Tennessee Wastewater Systems, Inc.
Docket 15-00025
June 2016 Report Overview

Subject: RE: As built

From: Brian Carter
Sent: Tuesday, May 10, 2016 8:32 AM
To: Allen Rather
Cc: Charles Hyatt; Jeff Ridsen
Subject: As built's required
Attachments: STARR CREST I AS BUILT.PDF; TOWNSEND TOWN SQUARE AS BUILT.PDF

TOWNSEND TOWN SQUARE
AS BUILT

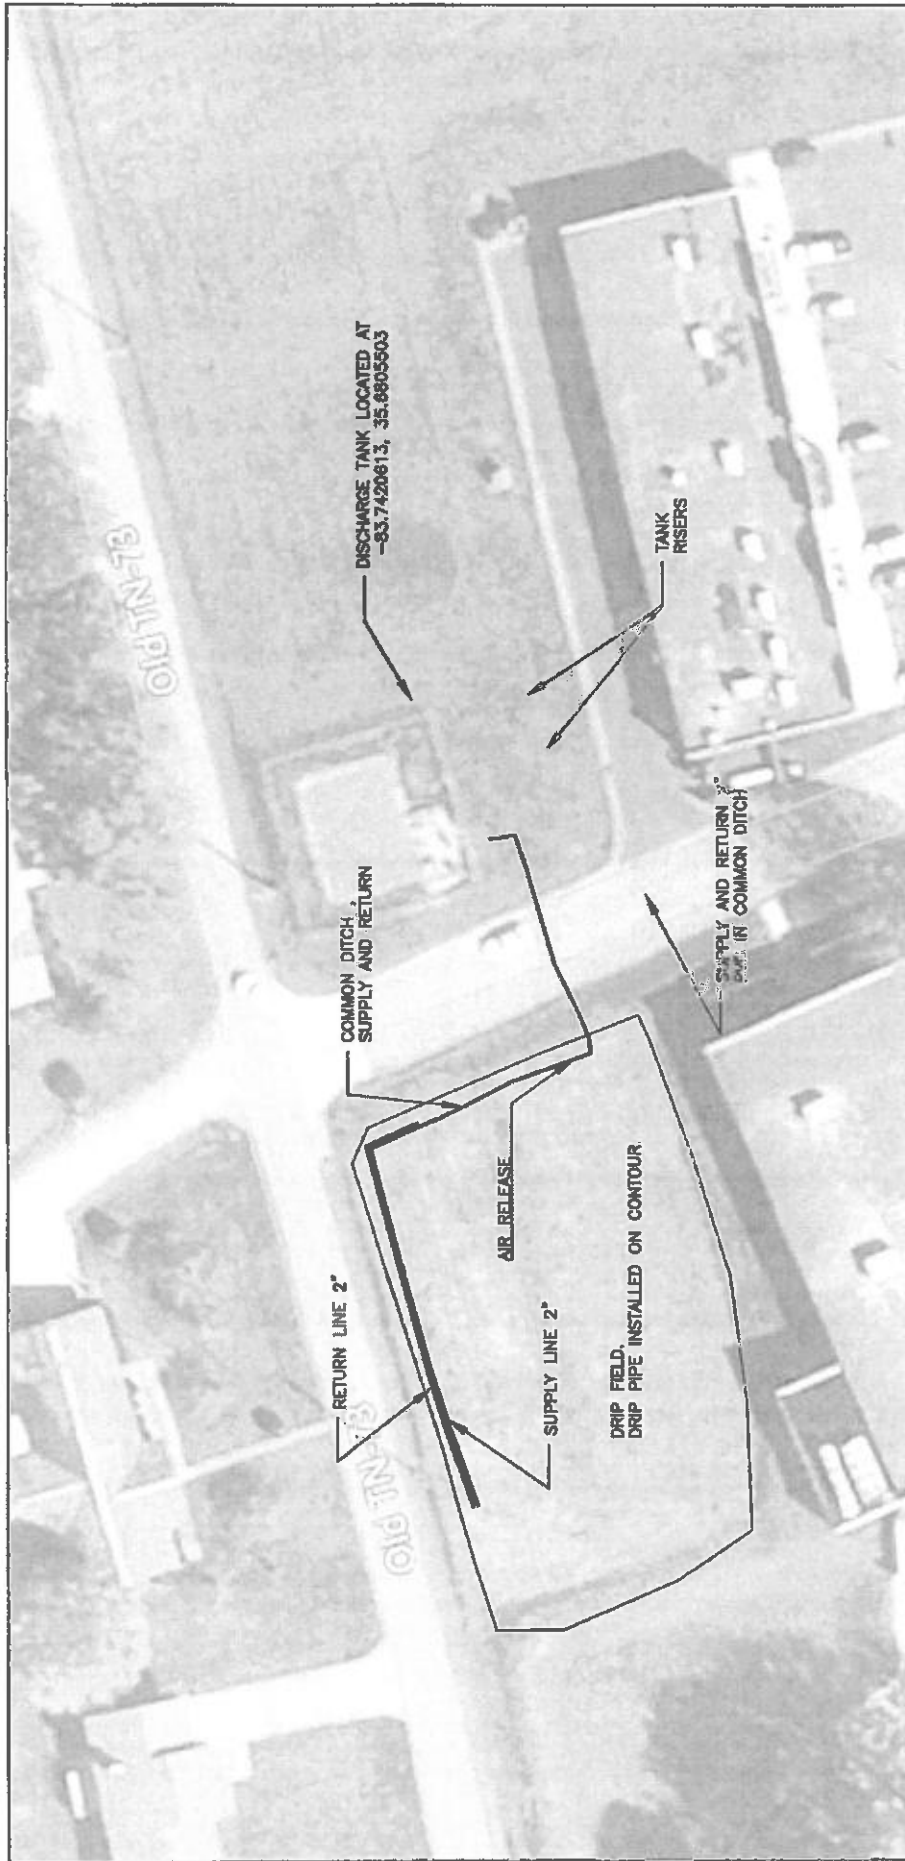
I talked with Brad about the plans you submitted. What he wants on these sites is a current as built showing manifold locations, air release and switching valves, and the location of the additional drip lines installed on a surveyed plat, complete with surveyor/engineer stamps.

Brian,
I talked with Brad about the plans you submitted. What he wants on these sites is a current as built showing manifold locations, air release and switching valves, and the location of the additional drip lines installed on a surveyed plat, complete with surveyor/engineer stamps.

Attached are the as built's you all were needing for the sites we discussed. This should be all left to remove these from the TRA monthly report. Let me know if you need anything else?
